RE: CBRN PAPR Concept Paper, April 1, 2004

3M Comments and Suggested Revisions to the April 1, 2004 CBRN PAPR Concept

Figure 1

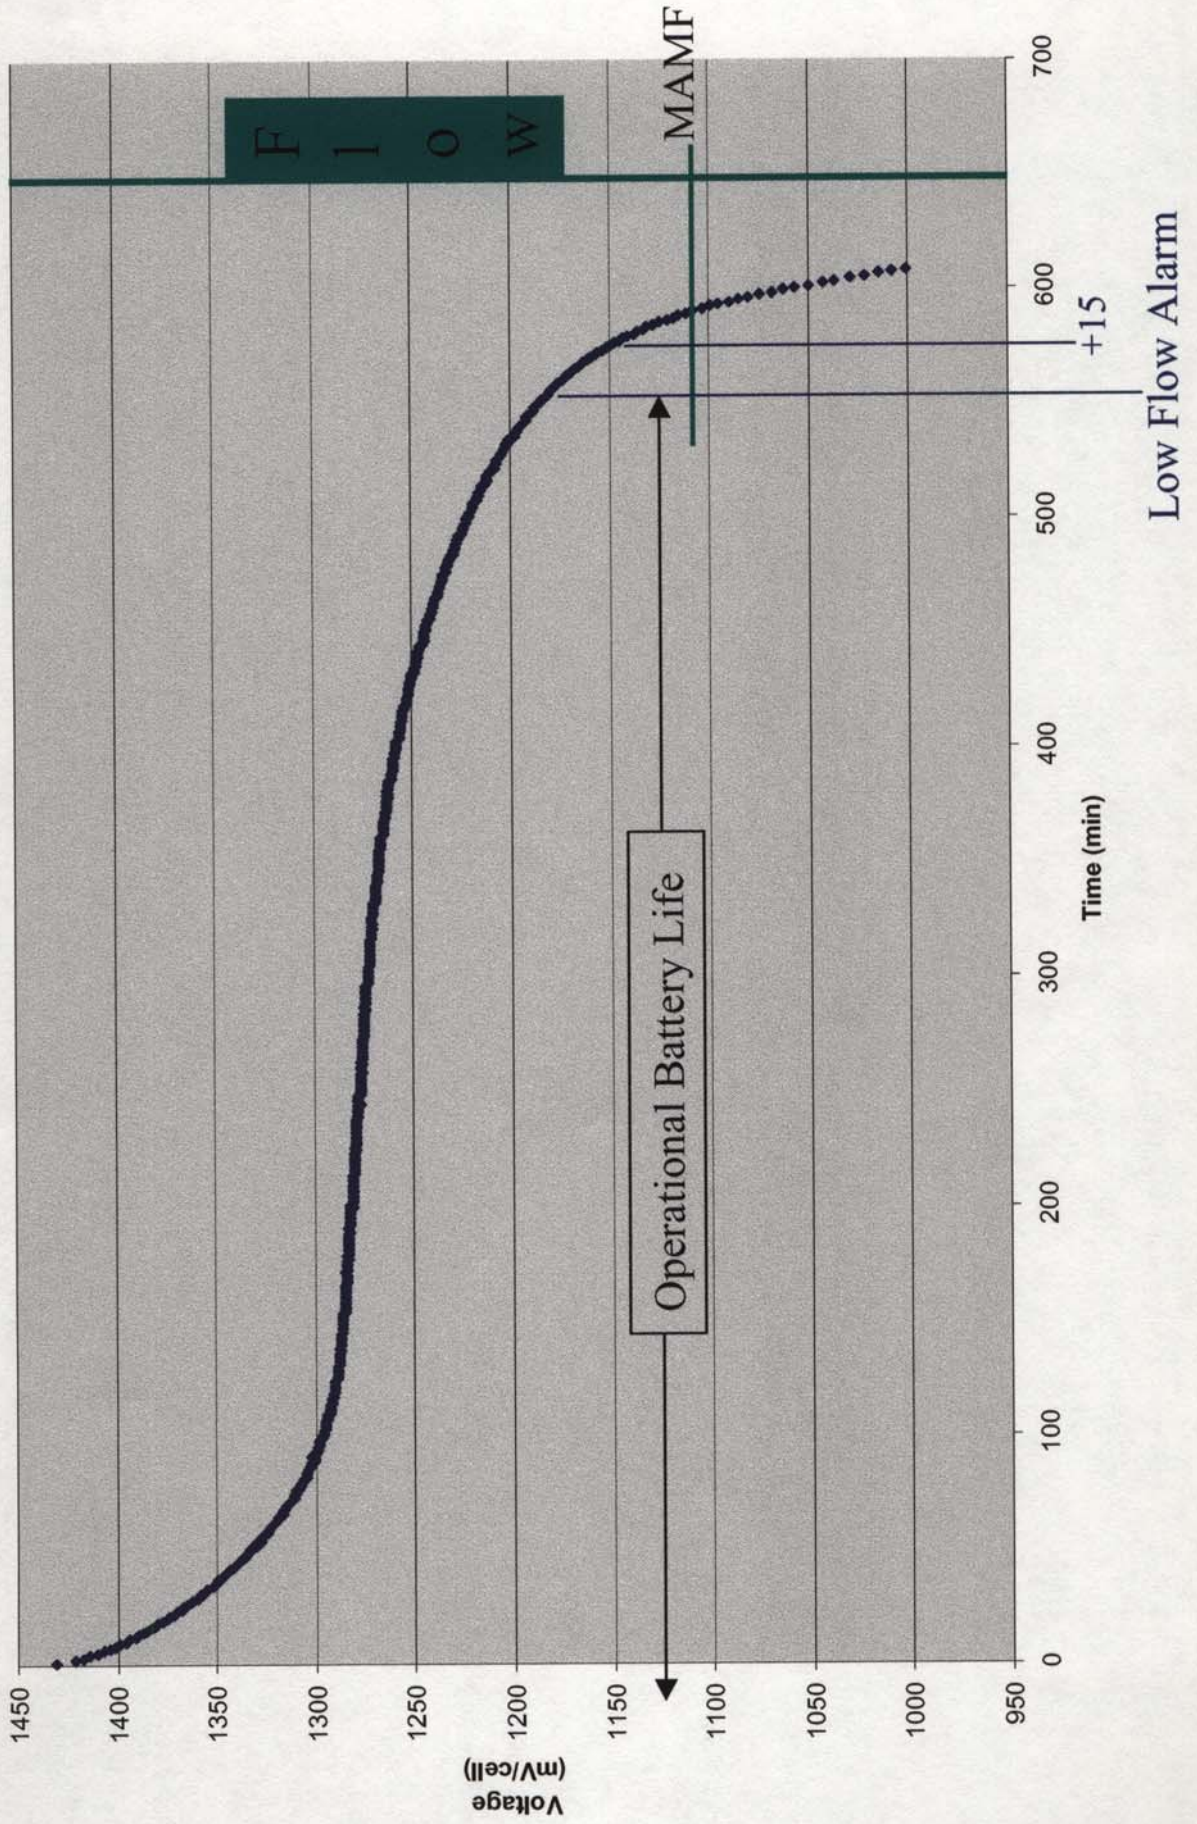
The manufacturer will also select a battery to provide an operational battery life based on what they think the market desires and what is technologically feasible. The operational battery life will be based on the desired time before the minimum acceptable flow is reached. According to the requirements of this concept, the low flow alarm would be set to go off 15 minutes prior to

reaching the MAMF. This point would determine the end of the operational battery service life (See Figure 1). The claim for an operational battery life is dependent on many things related to battery technology, especially use temperature and because of this, needs to be defined more thoroughly by NIOSH. (See Figure 2)

Operational Battery Life: The time, specified by the manufacturer, between when the system is activated with a fully charged battery and when the low *flow* alarm indicates plus fifteen minutes at 70°F +/-3°F.

Figure 2

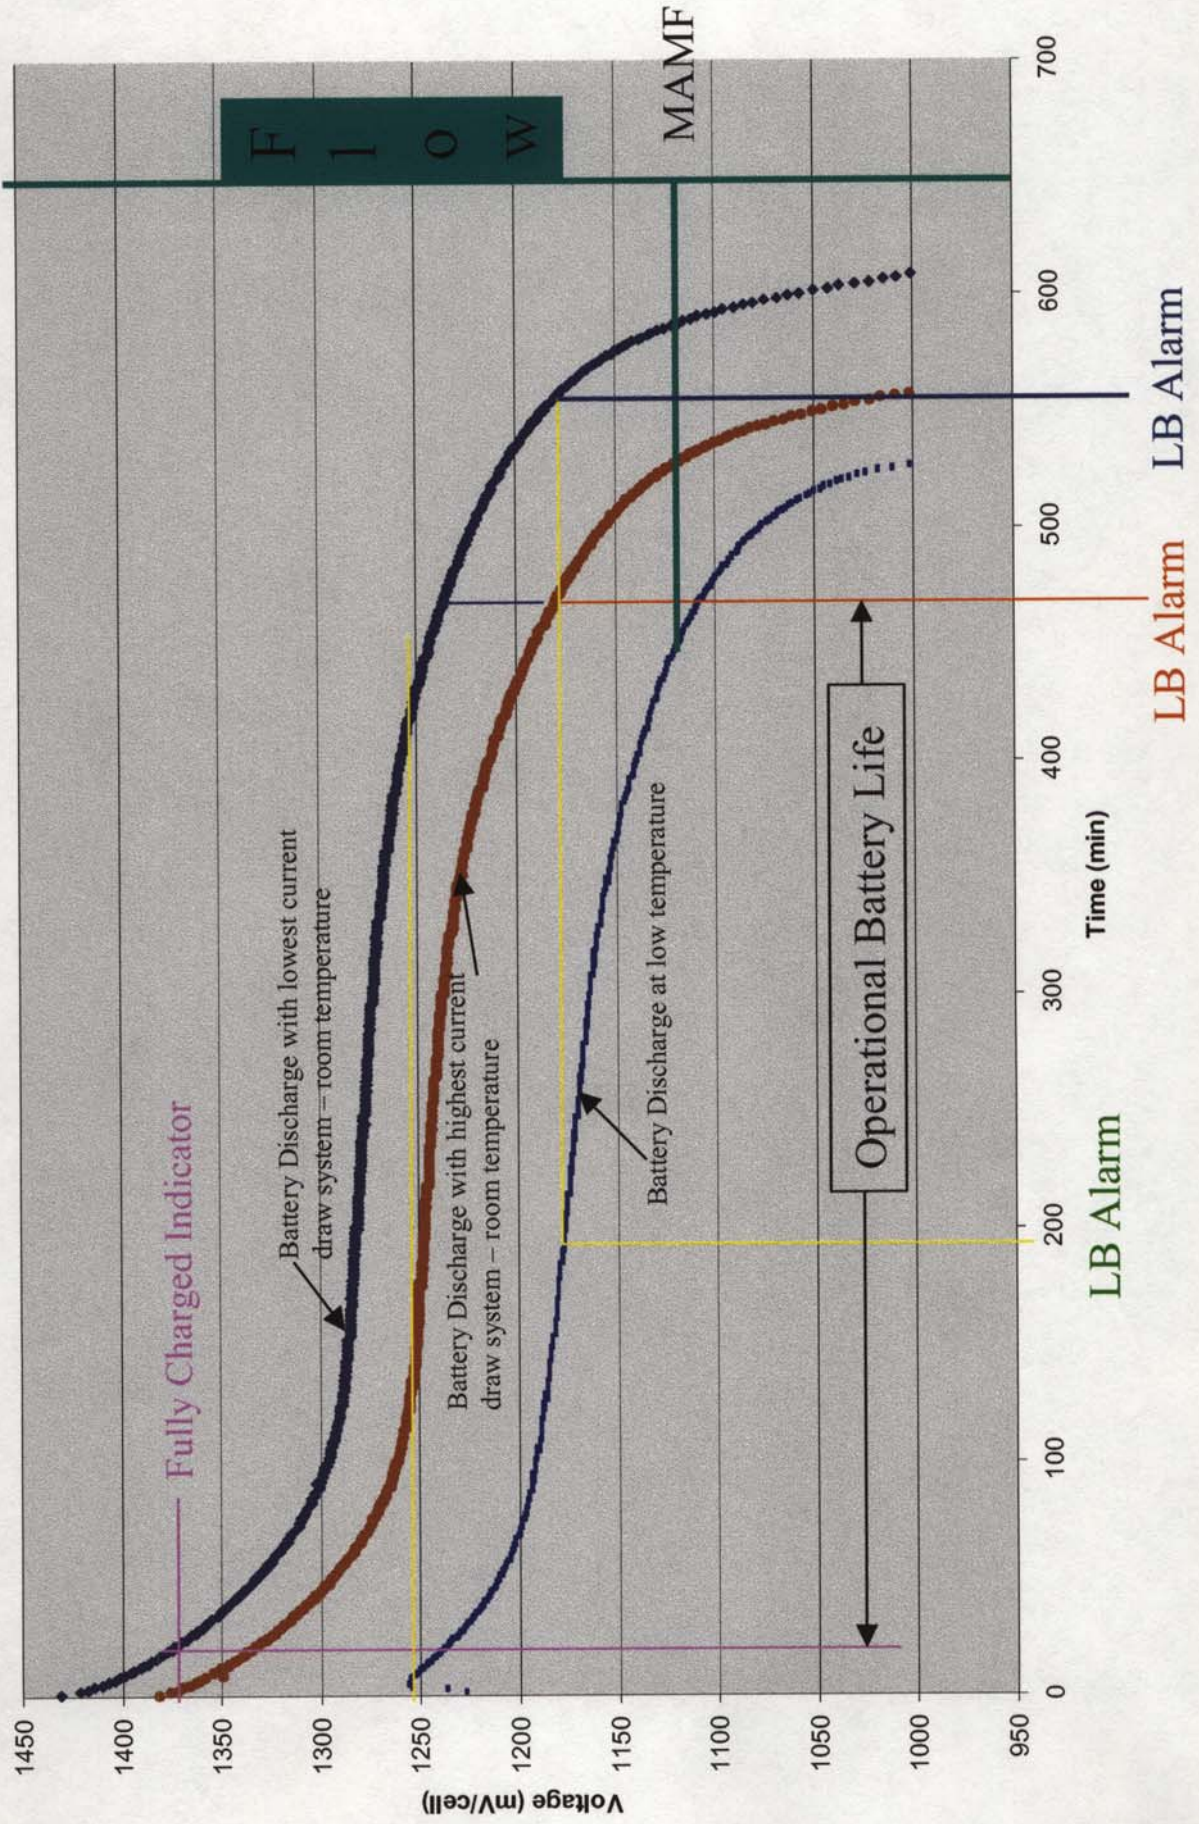
Figure 2 shows three battery discharge curves; two are at room temperature and the third is at a lower temperature to show the effect of low temperature on the operational battery life. The left vertical axis indicates voltage and the right vertical axis indicates airflow. An alarm voltage and the MAMF are also shown. This figure also illustrates why NIOSH does not want to require a low battery indicator. A low battery alarm, if used, may not indicate before a low flow alarm as in the case of heavy loading. A low battery alarm could also indicate before the low flow alarm if the system is used beyond the batteries' capacity e.g., low temperature. In either case, the low flow alarm alerts the user to the potentially unsafe condition; the low battery alarm does not.

There is no simple relationship between the two alarms. In the schematic, ~ 1.180 volts/cell is the point where the low battery indicator would alarm. As the low temperature discharge curve indicates, this indicator would alarm well before the manufacturer's acceptable minimum flow (MAMF) would be approached. Under these conditions, workers would be likely to ignore as it “cries wolf” by alarming less than half way into the operational life. Another shortcoming is that a low battery alarm may not indicate loss of flow due to filter loading.

Therefore, 3M recommends that the operational battery life be defined as:

Attachment 1 Examples of Loose fitting Respiratory Inlet Coverings

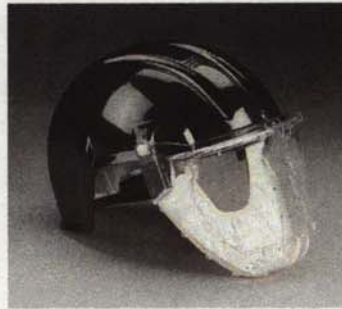
Attachment 1 shows examples of loose fitting respiratory inlet coverings.
